Summary Report of Stakeholder Engagement

Airspace Change Request ACP-2021-032

Author(s):	David Walters (david.walters@altitudeangel.com) Stephen Farmer (stephen@altitudeangel.com)
Document Version:	1.0 (5 th August 2021)

Below, we outline the current design dimensions:

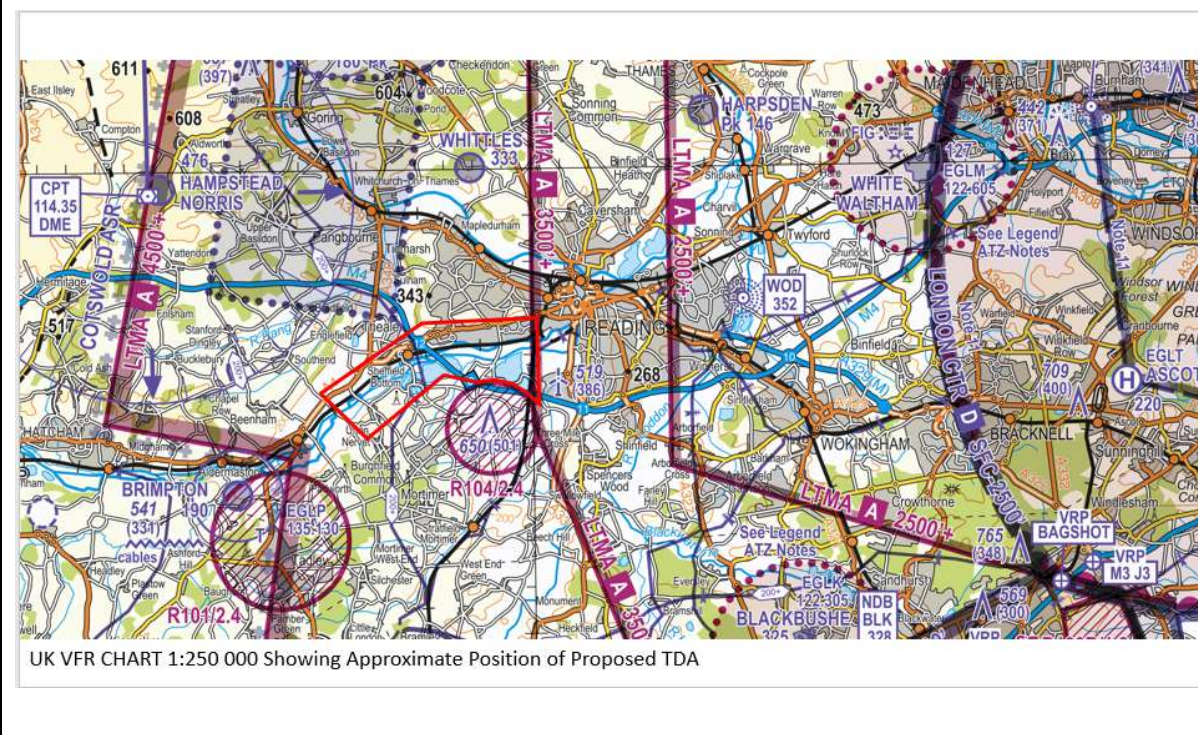
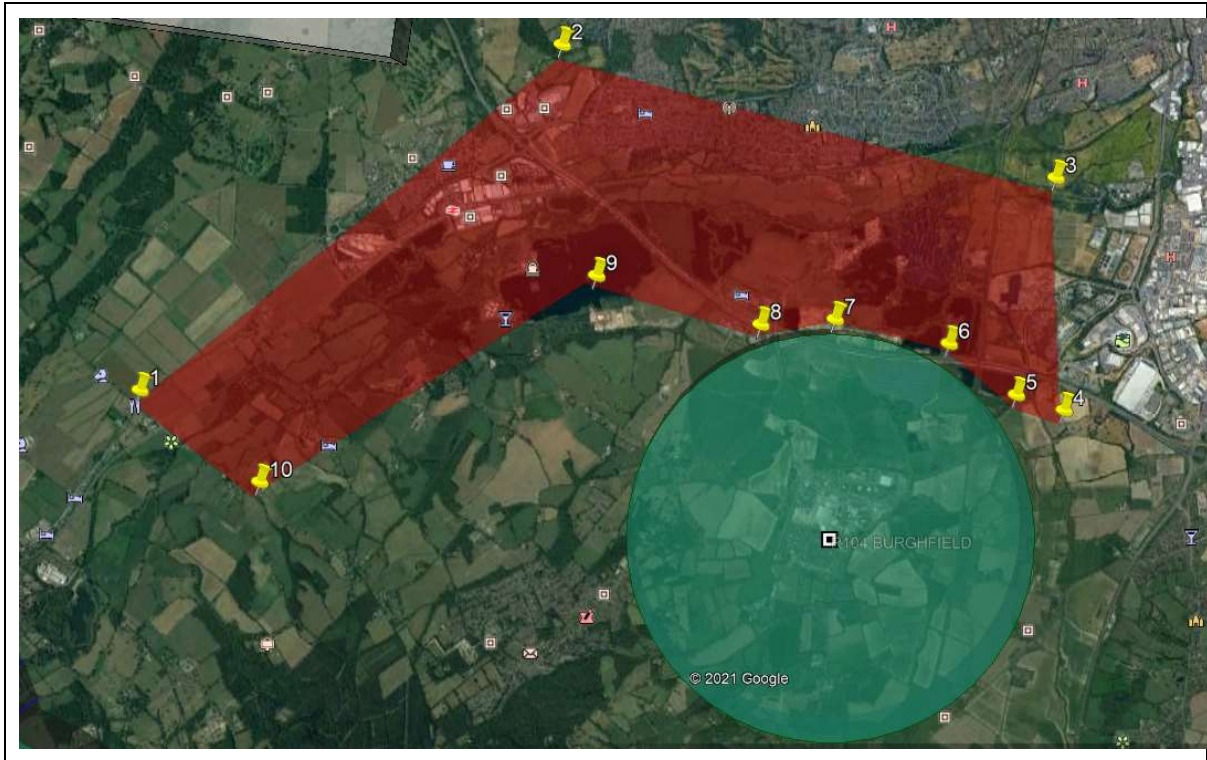
On receipt of feedback from stakeholders we have made minor changes to the extremities of the proposed area:

- 1) The Cessna 189 Group operate several light aircraft from the Englefield Estate at Whittles Farm Airstrip. We have reduced our TDA dimensions accordingly to ensure we do not restrict their take-off and landing.

Our TDA also intersected with R104 at Burghfield initially: we have now made amendments to this, so the lower south corner now follows the outer edge of this piece of airspace.

- 2) We have listened to the GA community response regarding congestion within the airspace due to low cloud cover at or below 1,000ft. We have acknowledged this and agree that the TDA and our operations would not be active when cloud cover is this low.
- 3) We were asked if we could keep the TDA North of the M4, due to it being a navigation aid for GA Pilots. Due to land access and ground-based hazards, re-routing the TDA as requested would not be possible, but we have reviewed the buffer and adjusted areas to the co-ordinates below, which we believe to be a reasonable compromise;
- 4) Some raised questions about the proposed upper limit of the TDA and requested we look to achieve 600ft AMSL, as opposed to 800ft AMSL detailed in our application.

Our TDA is now south of the runway, and runs parallel to their runway, which runs E/W.

The top of our Emergency Buffer Zone is 619ft AMSL. Taking into consideration that it is our belief that the CAA Policy Team will want us to ensure we have a good buffer zone between manned air traffic and drone operations, we believe it is appropriate therefore to maintain 800ft AMSL, however are prepared to amend this if the CAA Policy Team is amiable to this and we believe it can be handled safely.

UK VFR CHART 1:250 000 Showing Approximate Position of Proposed TDA

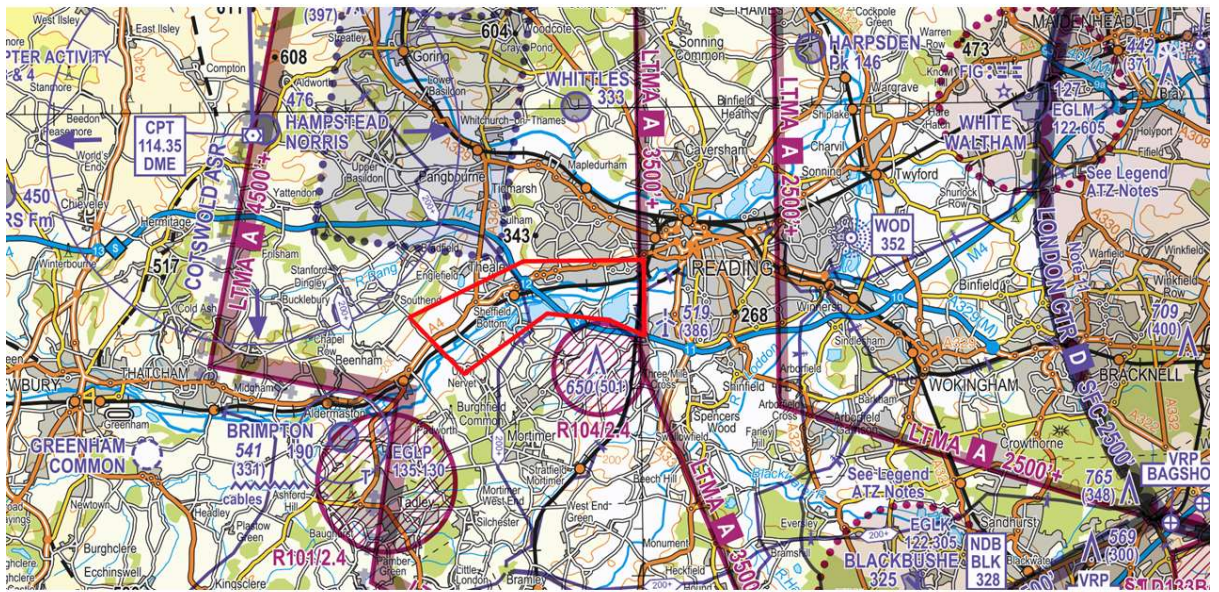
3. Whilst you have given detailed information on the area required for the TDA we would always request that this be presented on a current airspace chart, preferably the 1/4mil scale, considering the size of this proposed TDA. We appreciate that your Engagement Notice includes some representation but the chart used is not an appropriate scale. Actually, this issue is something we have consistently lobbied all sponsors and the CAA for as a fundamental requirement. The clue is in the name; it

is an *Airspace* Change Proposal where you need to engage with aviation stakeholders so it seems obvious that it would be necessary to represent the proposed Change on an *airspace* chart. This provides a level of clarity with regard to the impact any TDA could have on airspace users relative to existing airspace. It seems this is a common failure with virtually all UAV ACPs and we feel shows a level of ignorance of airspace matters. We are puzzled why the CAA don't insist on this as we cannot see them accepting an ACP from a major airport for revised airspace on a satellite map. The process is the same irrespective of what the Change is for so it seems sensible the same rules should apply. It would certainly enhance your application in the eyes of the CAA, I'm sure.

We have added an aviation chart to the uploaded and updated Stakeholder Letter V4 on the ACP Portal. We took the feedback from our first responses and uploaded the updated version. Since then we have obtained a digital copy of the VFR chart for the south and will be uploading it shortly. I do agree it would be better on the ACP planning tool if the CAA had the VFR Charts back loaded so we could draw directly on to them. It would be easier for everyone, I think!

Thanks, the 1:250,000 chart representation is much clearer and we appreciate your prompt and positive response to that request. It immediately shows proximity to any other airspace and any airfields and would be so much better if more drone sponsors were so motivated! It almost seems some purposely want to hide such proximities. A lesson for the CAA we think.
